Response to Comments on the Draft NPDES permit for the PotlatchDeltic Corporation St. Maries Complex

EPA Region 10
Water Division
Permitting, Drinking Water and Infrastructure Branch
NPDES Permitting Section
July 2022

Figure 1: Effluent Flow for Outfall 001 vs. River Flow

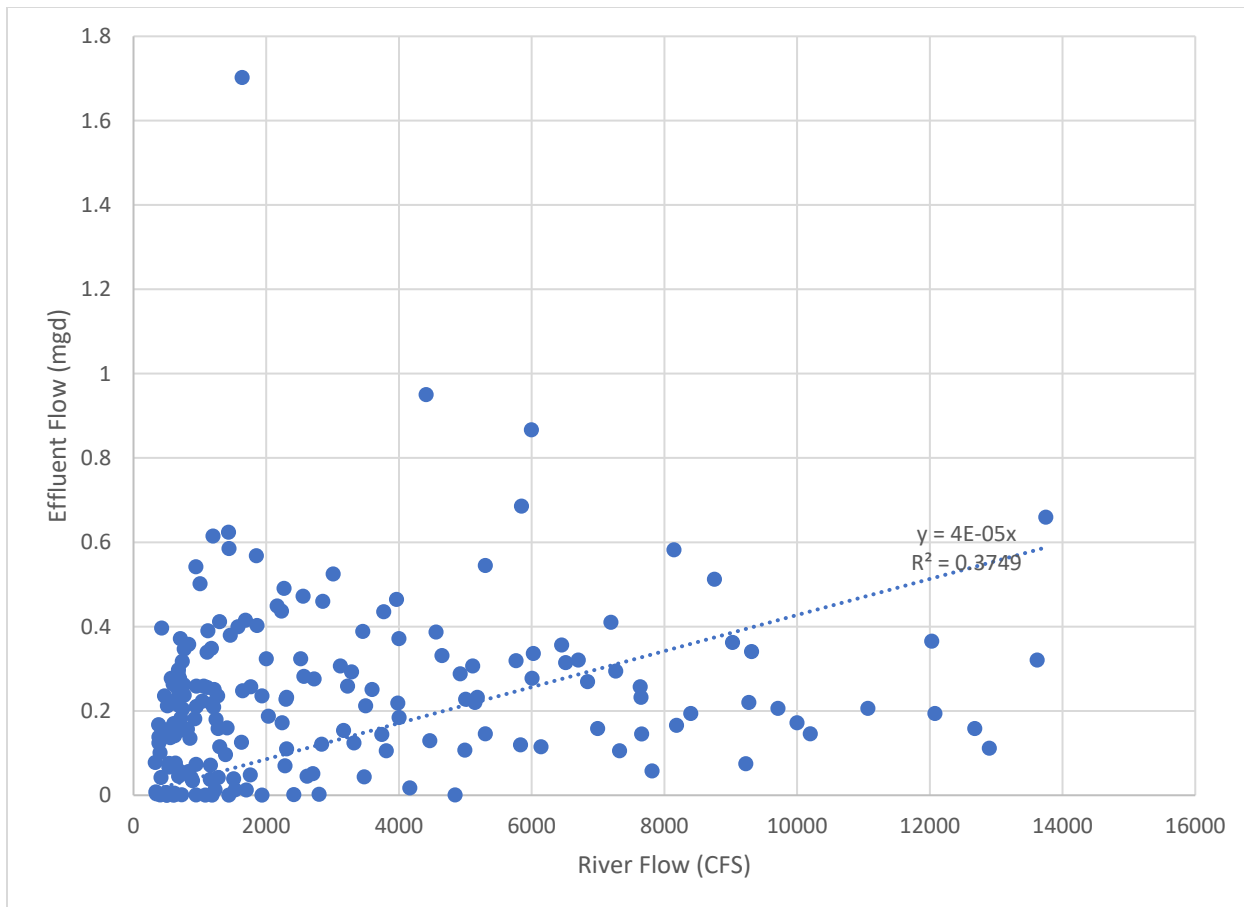
Although EPA acknowledges the uniqueness and challenge of setting effluent limits for stormwater discharges with numeric limits in the Fact Sheet at p. 24, the reasonable potential analysis fails to take such an undertaking into consideration. It stands to reason that when stormwater discharges are occurring there will be increased flows in the river; however, EPA does not consider this reality.

In the Fact Sheet at p. 24 in Part IV.E. Stormwater Discharges, EPA has explained how the characteristics of stormwater influence the analysis for whether water quality based effluent limits are necessary and the calculation of those effluent limits. While stormwater is a type of non-continuous discharge, EPA had sufficient data from the facility concerning the discharge to calculate effluent limits for the outfalls. In addition, EPA conducted the reasonable potential analysis and calculated the effluent limits consistent with federal regulations (40 CFR 122.44(d)(1) as well as Section 3.3 of the TSD.

A plot of monthly average effluent flows for outfall 001 against monthly average stream flows for the St. Joe River shows a weak relationship between effluent flow and stream flow (Figure 1). Thus, it is reasonable to use critical low flows such as the 7Q10 to establish effluent water quality-based effluent limits for the Potlatch/Deltaic St. Maries complex. No change was made to the permit as a result of this comment.

Figure 2: Zinc Effects on Mortality, Growth and Reproduction by Species Group

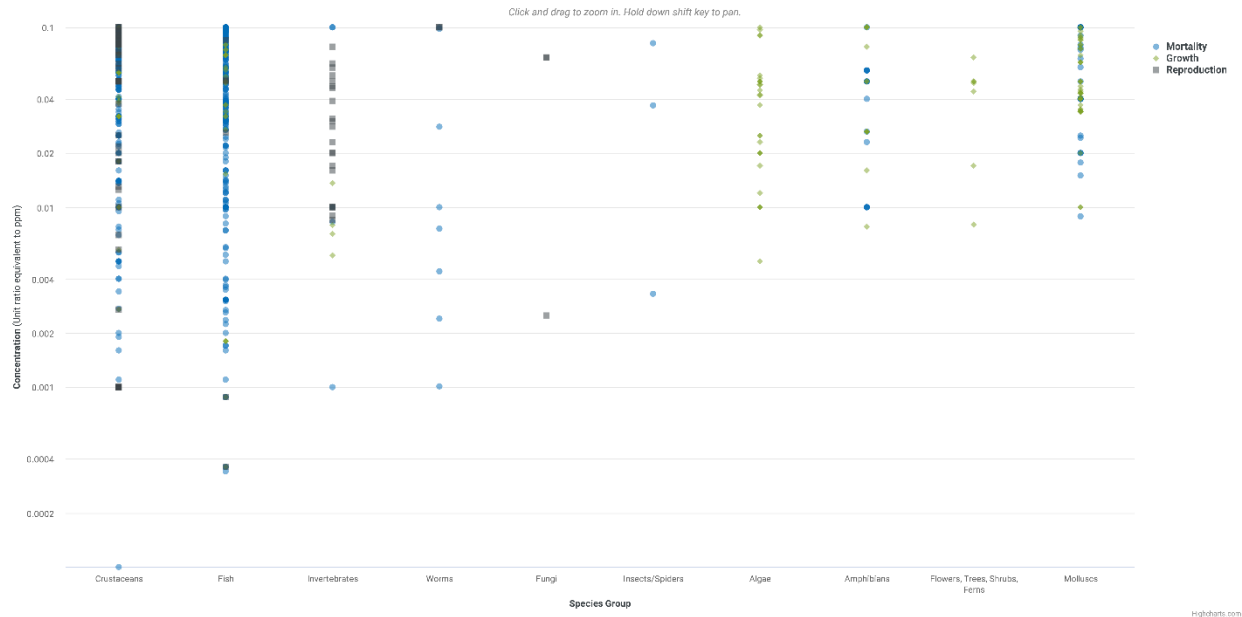
PotlatchDeltic requests that a hardness value of 400 mg/L be used to set the zinc limit for the Unnamed Ditch. 400 mg/L is the maximum hardness value allowed for use in the equations used to calculate effluent limits for certain metals (e.g., zinc) under water quality standards at IDAPA 58.01 .02.210.c.i. Based on the hardness data collected between August 5, 2021 and September 16, 2021, the 5th percentile hardness value is 526 mg/L. The 10th percentile hardness value is 773 mg/L. The hardness value chosen to set the zinc limits for the Unnamed Ditch (i.e., 279 mg/L) is the minimum value from the dataset and is 2.8-7.1x lower than the other values in the dataset. The value 279 mg/L lies at an abnormal distance from the other values in the dataset and should be considered an outlier. The hardness value chosen for use to set limits for zinc was based on concern for a greater aquatic toxicity effect from zinc due to a low calcium-to-magnesium (Ca:Mg) ratio in the Unnamed Ditch relative to the Ca:Mg ratio in the St. Joe River. The Unnamed Ditch does not support aquatic life, which mitigates the concern for aquatic life toxicity within this water channel.

As explained on Page 16 of the February 16, 2022 fact sheet, although EPA generally uses the 5th percentile hardness value to calculate water quality criteria for hardness-dependent metals, “it is appropriate to use a more conservative hardness value due to the small sample size (n = 11) collected over a period of only 42 days and low calcium-to-magnesium ratios relative to the St. Joe River. Calcium has a greater mitigating effect on zinc toxicity than magnesium, thus, at a given hardness, the toxicity of zinc will be greater with a lower calcium-to-magnesium ratio.”

There is no evidence for the commenter’s statement that the unnamed ditch does not support aquatic life. Even if there are no fish in the ditch, zinc can have effects on other types of aquatic life such as crustaceans, invertebrates and worms, at low concentrations, as shown in Figure 2, which was generated using EPA’s ECOTOX Knowledgebase (<https://cfpub.epa.gov/ecotox/>). No change was made to the permit as a result of this comment.
